City of Charlotte

Zoning Committee Agenda

**Tuesday, December 5, 2017
5:30 p.m.**

1. Rezoning Petition: 2016-120 by Charter Properties, Inc.

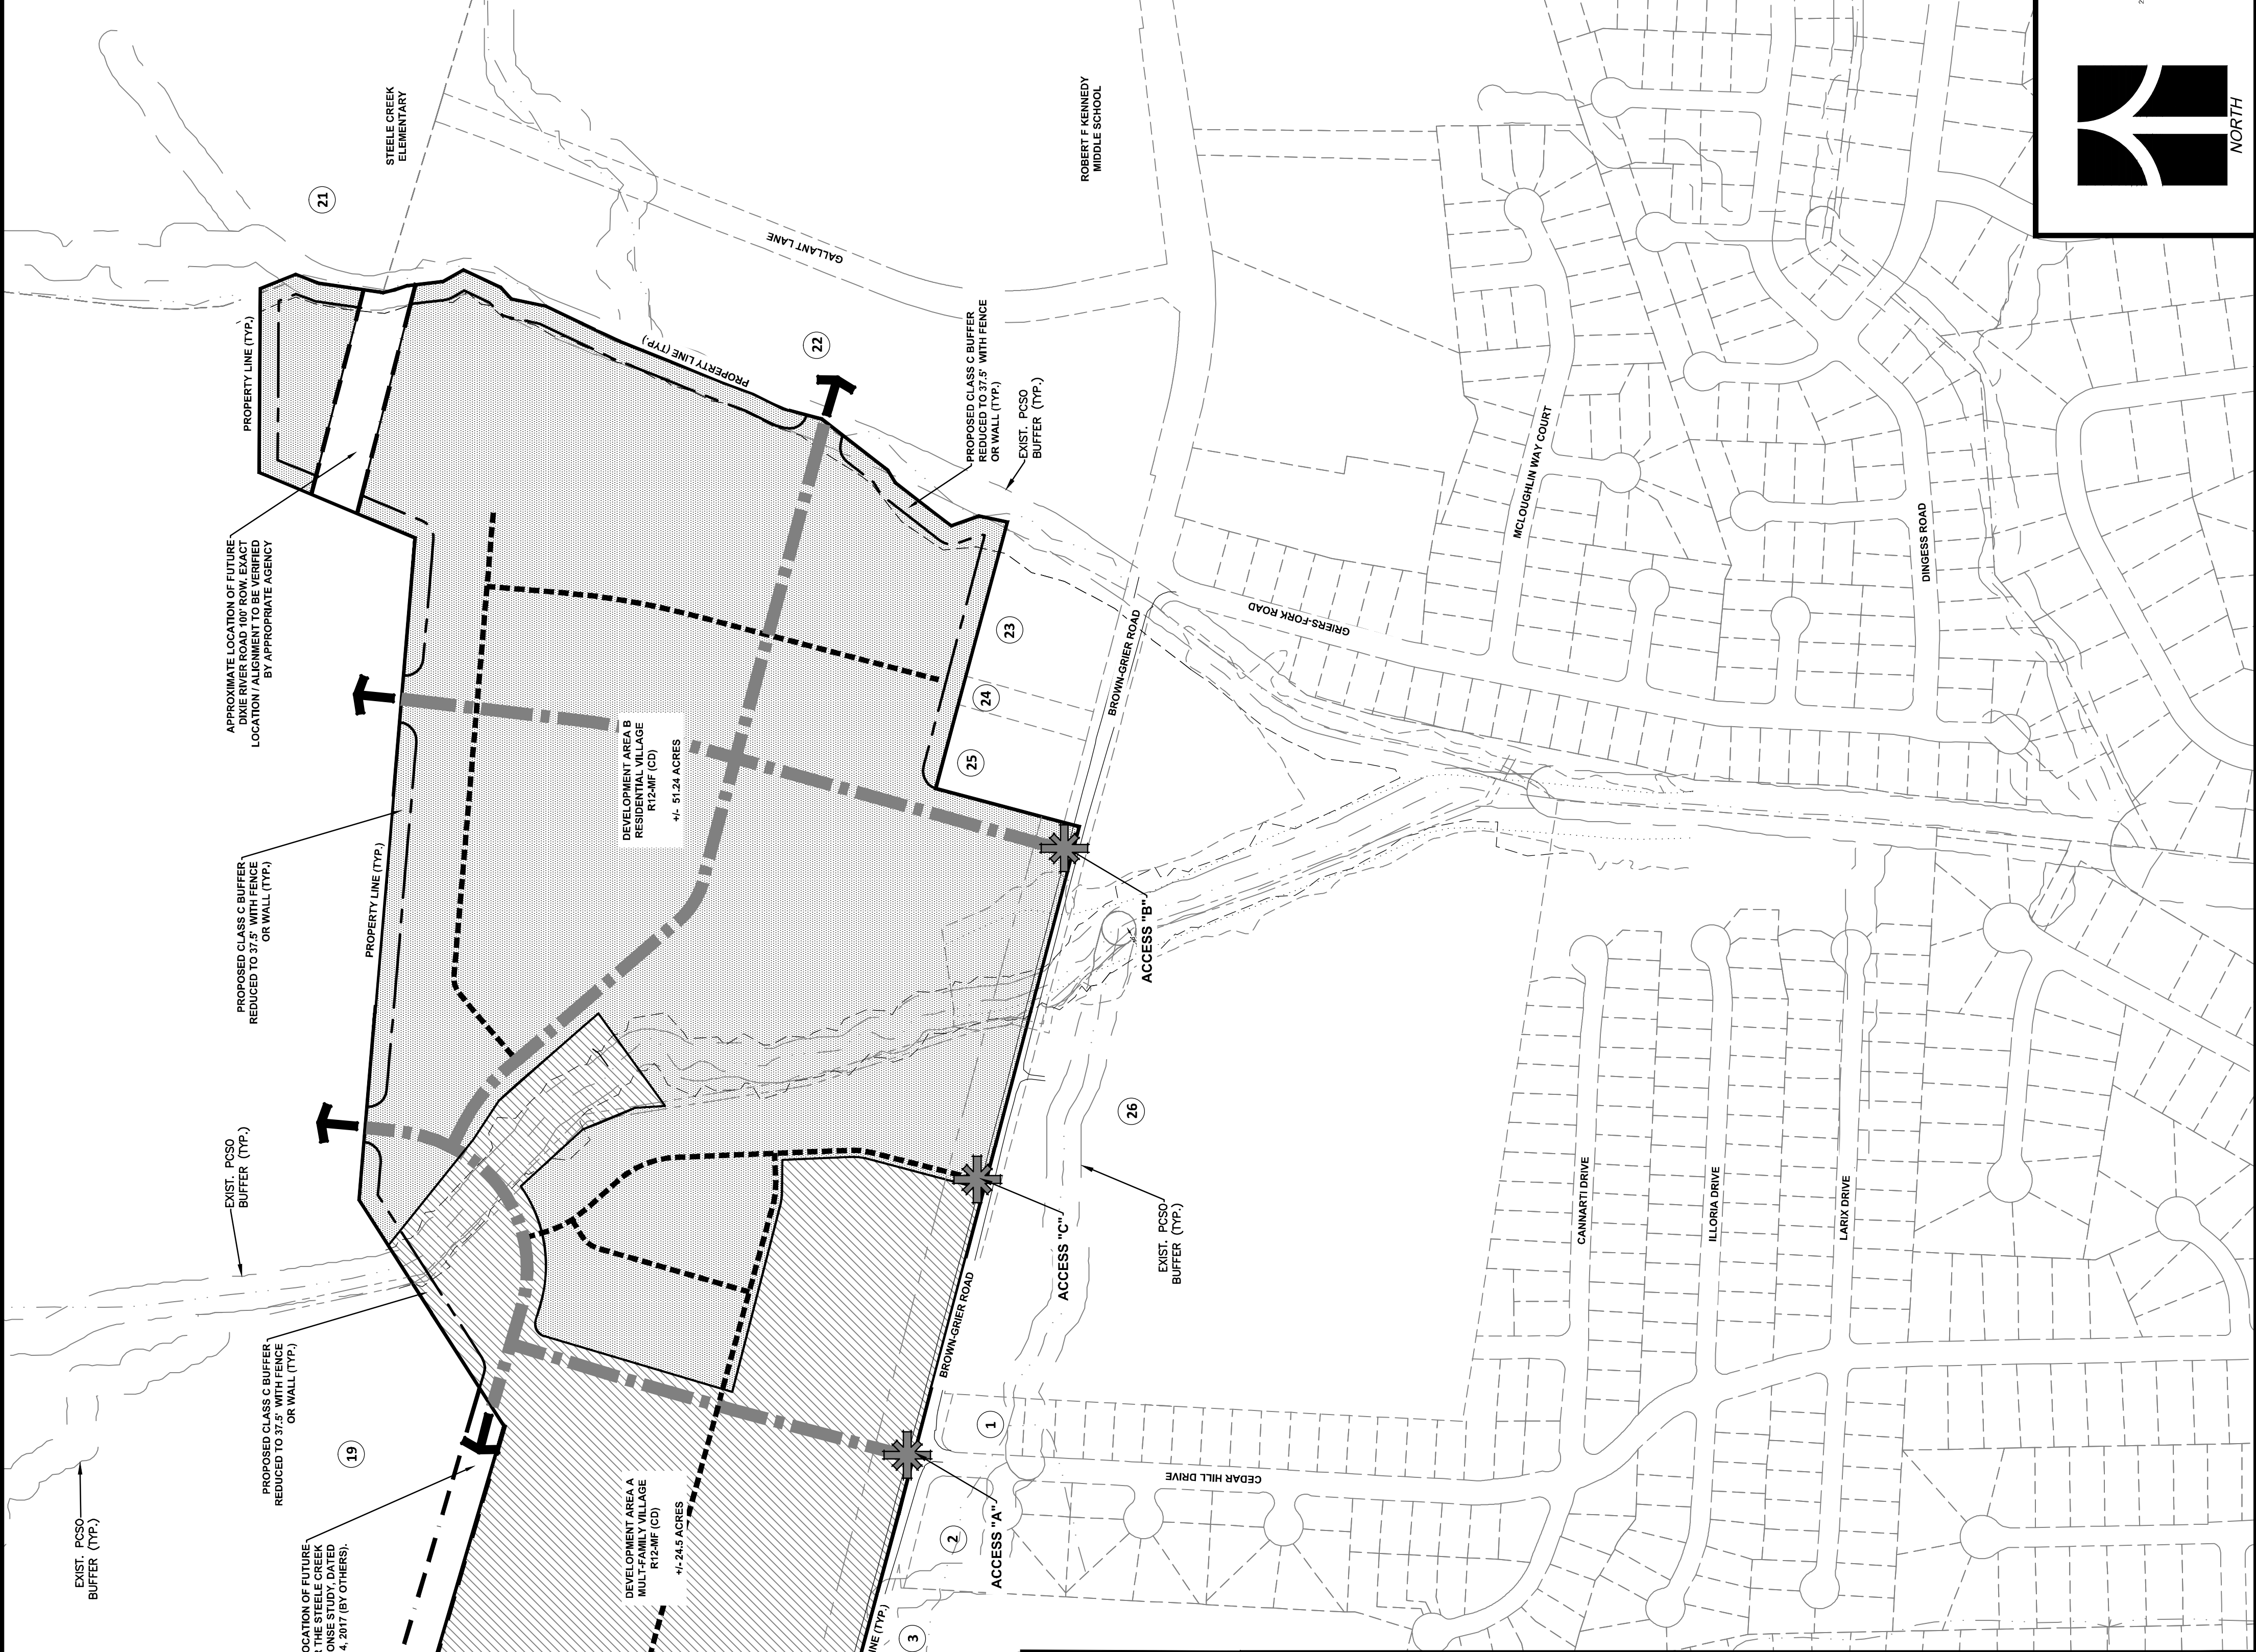
1. ~~Please show and label stream buffers on rezoning plan.~~ **Addressed**
2. ~~Please either delete Note D under the Environmental Features heading or revise note to read as follows: "The petitioner shall comply with the Charlotte City Council approved and adopted Post Construction Stormwater Ordinance."~~ **Addressed**

3. **Change Note 6.C. to read: The tree save areas depicted on the Rezoning Plan are conceptual, and the actual locations of the tree save areas on the Site may vary from what is depicted on the Rezoning Plan. The actual locations of the tree save areas shall be determined prior to the first plan approval during the permitting process. New issue based on revised site plan. The petitioner addressed this issue.**

5. ~~Show trail along both sides of open space/tree save area. Connect units to trail and proposed amenity areas.~~ **Addressed**
6. ~~No alley loaded elevations have been provided, and should be included in the submittal.~~ **Addressed**
7. ~~Provide windows in all front loaded garage doors.~~ **Addressed**
8. ~~Increase porch/entrance architectural element to be more prominent.~~ **Staff rescinded this request.**
9. ~~For front loaded units, either change the setback of garage door so it is located behind the front door or change to rear loaded.~~ **Addressed by providing a minimum of 66% or 201 units that will be rear loaded units.**
10. ~~Revise Architectural Standards Note A(3)(d)(ii) language "Patios and porches, if any, shall make a connection to the sidewalk." Petitioner needs to commit to providing this element.~~ **Addressed**

11. ~~The petitioner should remove Note 3H as it conflicts with Note 3I.~~ **Addressed**

12. ~~Note 2A.1 includes a playground to be located in Area A, but Note 7.F does not make mention of a playground in Area A.~~ **Addressed**
13. ~~Clarify if roll out carts are to be method of refuse/recycling for acreage to be developed with single family attached dwelling units.~~ **Addressed**

RZ-02

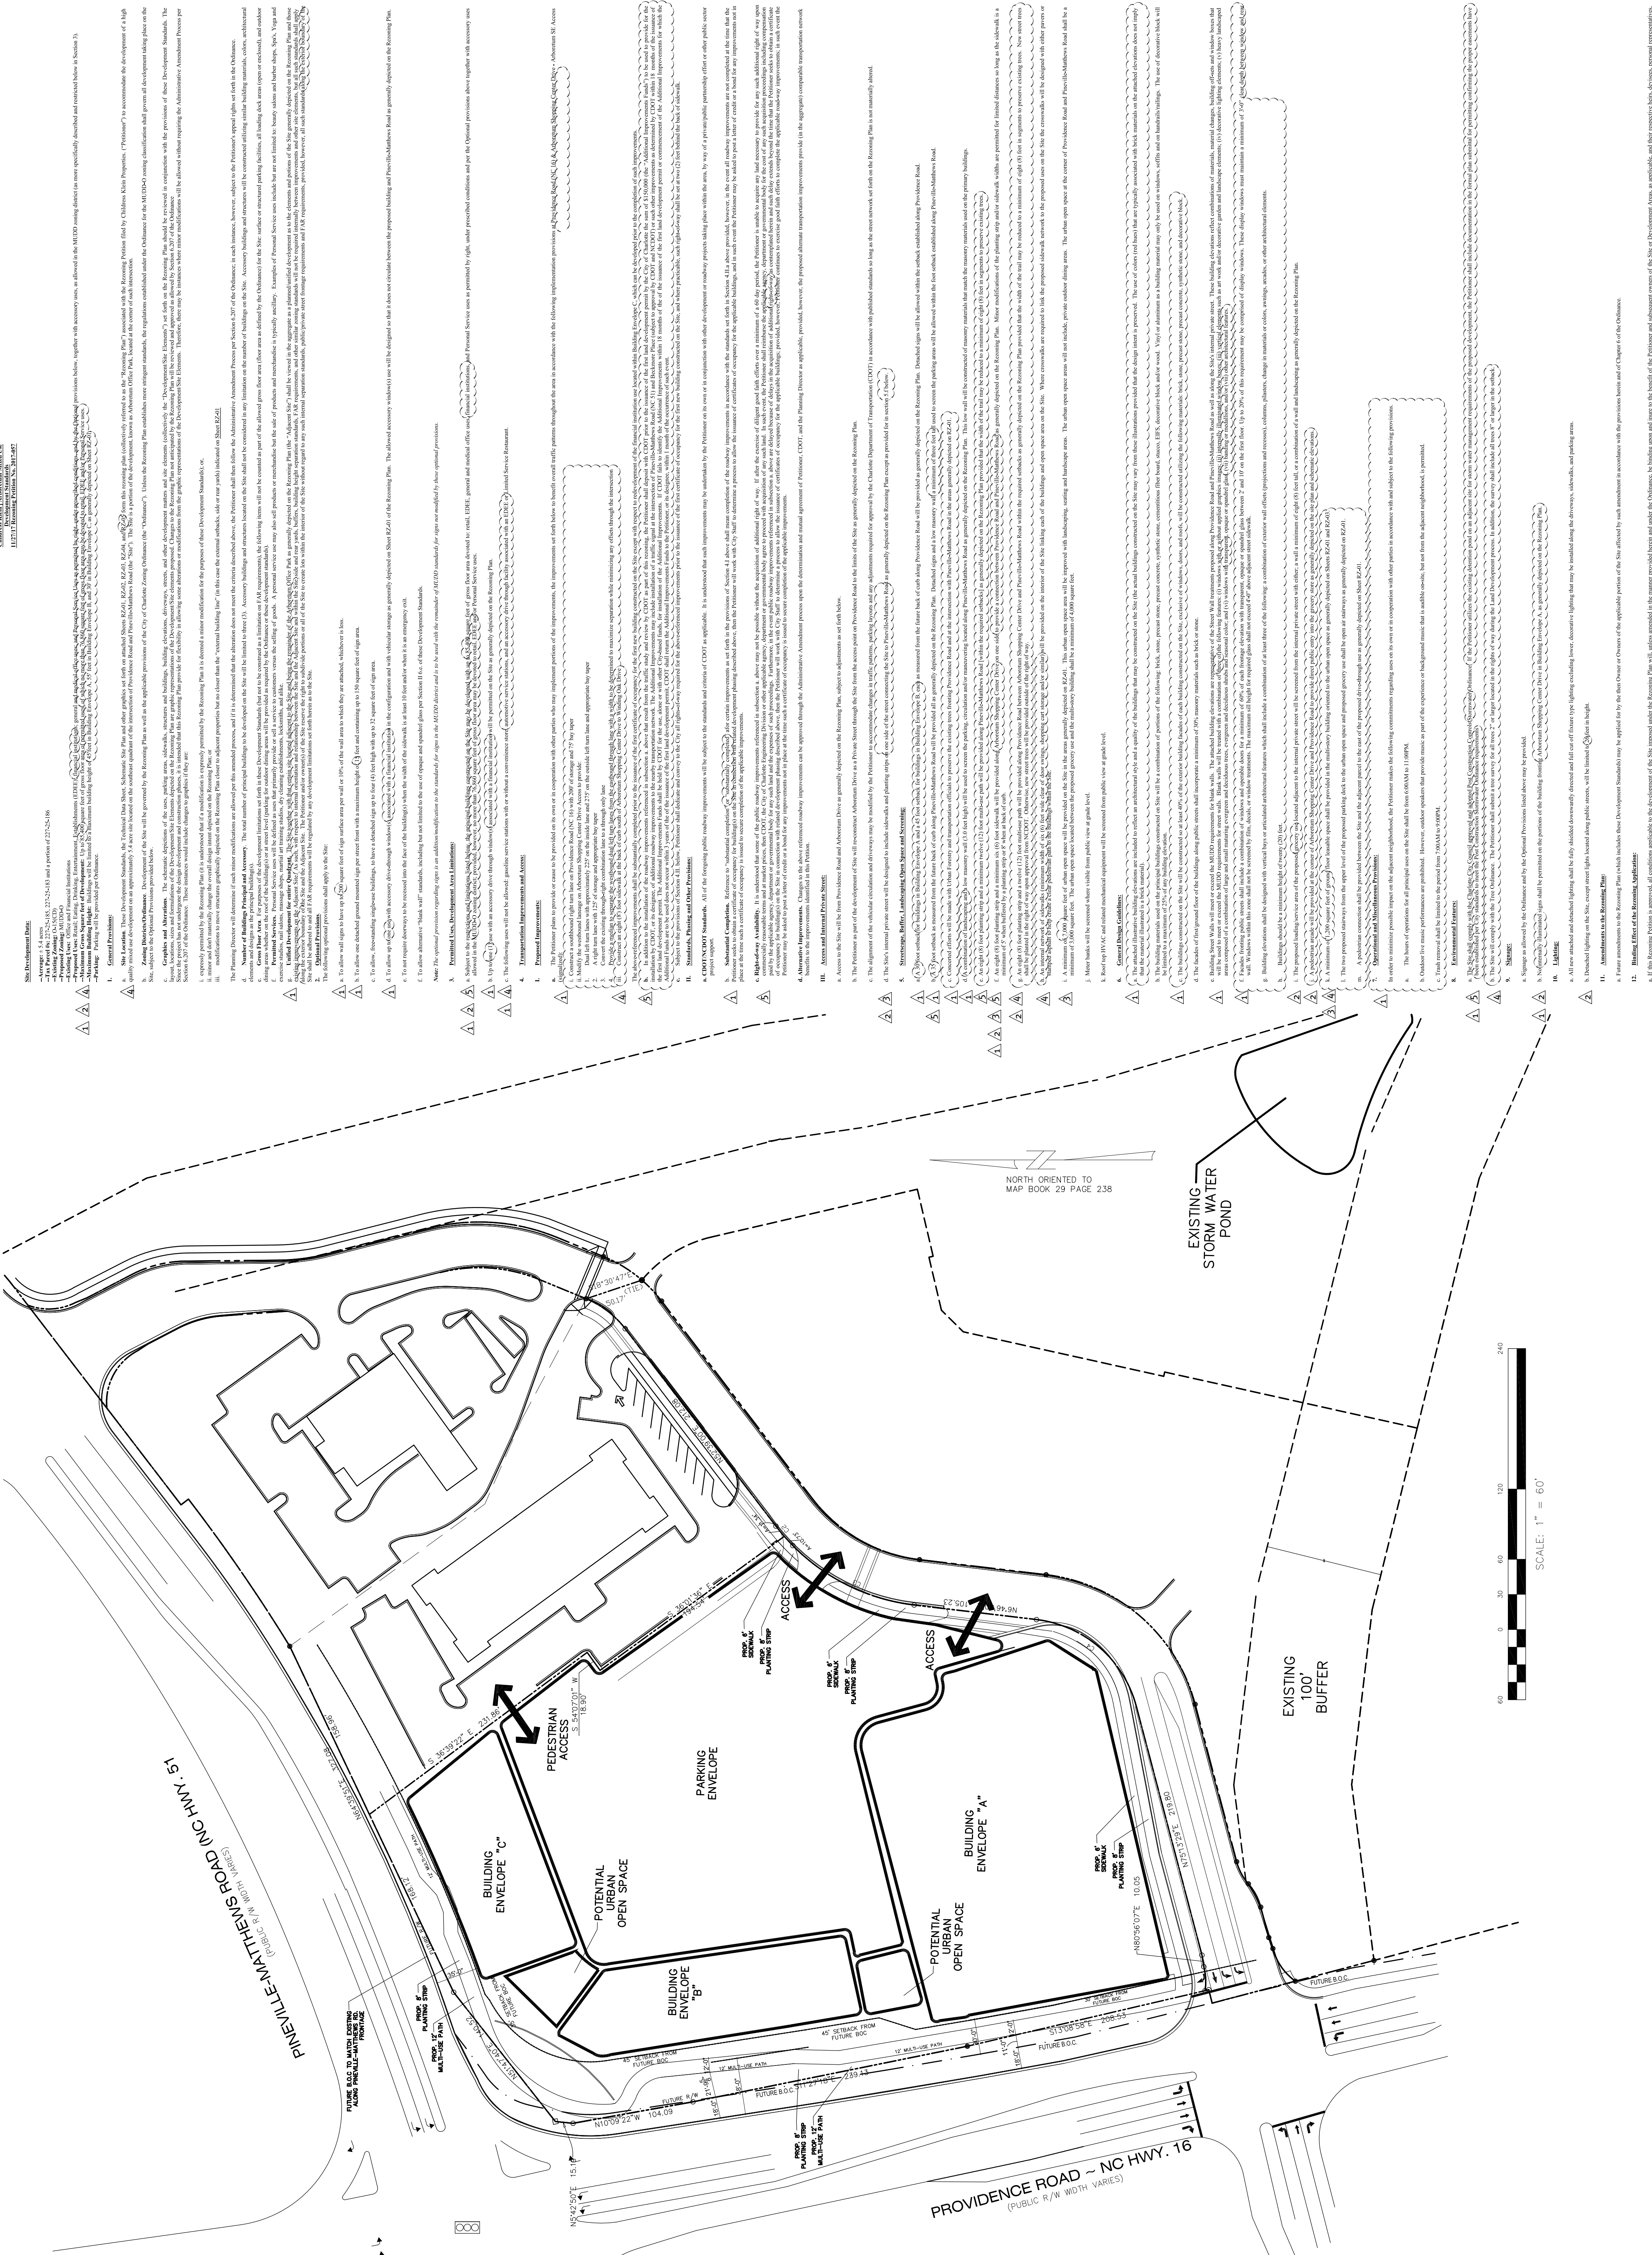
1. ~~Change the setback from 20 feet from the future right-of-way to 35 feet from the future back of curb along Pineville-Mathews Road on the site plan and legend on RZ-01, the technical data sheet on RZ-2, Note 5.b, and the enlarged frontage plan of RZ-05. Addressed~~
2. ~~Provide additional annotations on the building renderings and elevations including:~~
 - ~~Change of materials and insets in the loading view;~~
 - ~~Change of materials of the façade, as shown on the following elevations: mixed use building, mixed use building Providence, internal street, main entry, and Providence Road;~~
 - ~~Corner architectural building feature in the views showing the corner of the building at the internal street and Providence Road; and~~
 - ~~Store front entry and glass for the retail space and stairs to the upper level in internal parking deck elevation. Addressed~~

4. ~~Show the extension of the right-of-way across Arboretum Shopping Center Drive for the future widening of Providence Road. Addressed, the petitioner made the change in two of three places in the plans and committed to making the change on the third location.~~
